Agenda Item # 2 - HOLDOVER

SUB-003642-2026

Willis-Sermon Connector Subdivision

WILLIS-SERMON CONNECTOR SUBDIVISION

DETAIL SITE PLAN

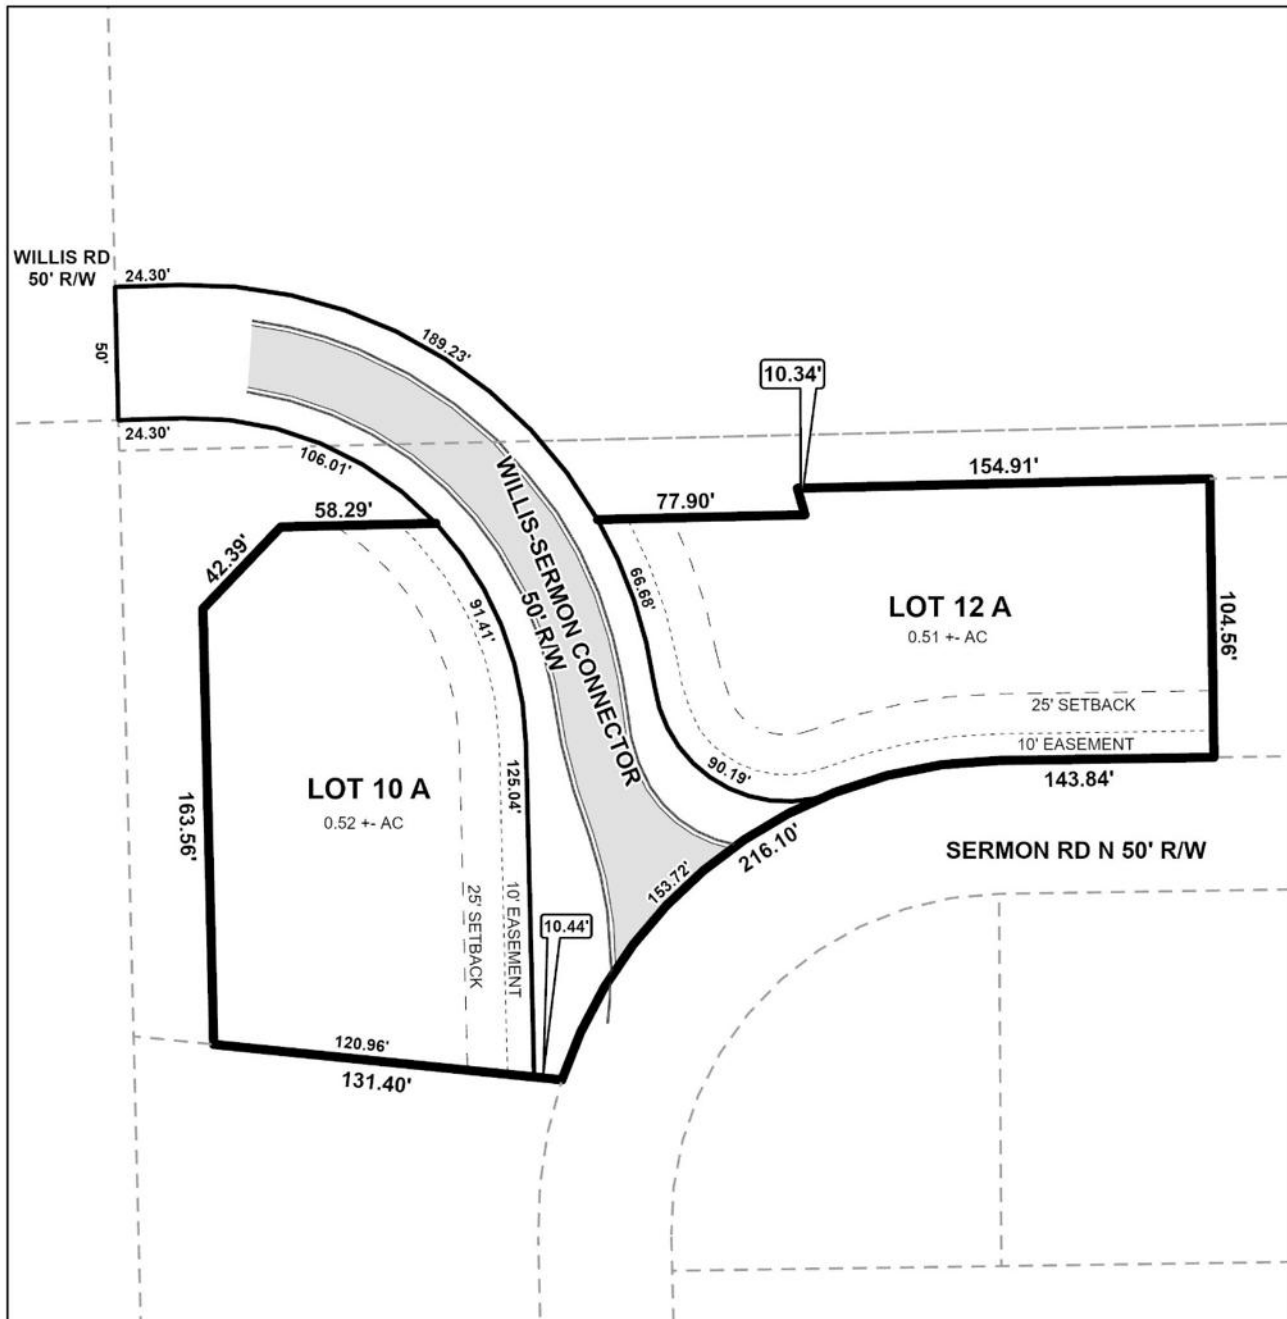
- C. Show the "old" lot line of the COMMON AREA (DETENTION) that bisects the proposed ROW.
- D. SURVEYOR'S NOTES #7 – include the amount of ROW dedication (acres and SF).

- B. *Provide a written description for the subdivision boundary. The ROW description is correct; however there needs to be a separate written description for the subdivision on the west side of Willis-Sermon Connector (LOT 10-A and Common Area- A) and for the subdivision on the east side of Willis-Sermon Connector (LOT 12-A and Common Area- B). There should not be four (4) separate written descriptions for the 2 lots and 2 common areas.*

The preliminary plat indicates that the connector street is located not only within the boundaries of the recorded *Collins Subdivision, First Addition*, but also extends into the boundaries of *Collins Property Subdivision*, a one (1)-lot subdivision immediately north of the subject site that is not included in the current application. Because the proposed subdivision would alter the boundaries and area of that subdivision, *Collins Property Subdivision* should also be incorporated into the current application, which would revise the proposal to create three (3) lots rather than two (2).

Additionally, the recorded plat of *Collins Subdivision, First Addition* identifies a Common Area intended for detention purposes that is bisected by the proposed subdivision. This Common Area would therefore need to be included within the boundaries of the proposed subdivision. As the recorded plat establishes that the Common

- 1) Revise the application to reflect a three (3)-lot subdivision, including the area of Collins Property Subdivision as the third lot;
- 2) Revise the plat to include the Common Area of Collins Subdivision, First Addition, within the boundaries of the proposed subdivision;
- 3) Obtain written consent from all property owners within Collins Subdivision, First Addition, for submission of the application, as the Common Area must be included; and
- 4) Re-advertise the subdivision request as a three (3)-lot subdivision, including notifying property owners adjacent to and across public streets from the Collins Property Subdivision area, as well as all property owners within Collins Subdivision, First Addition.
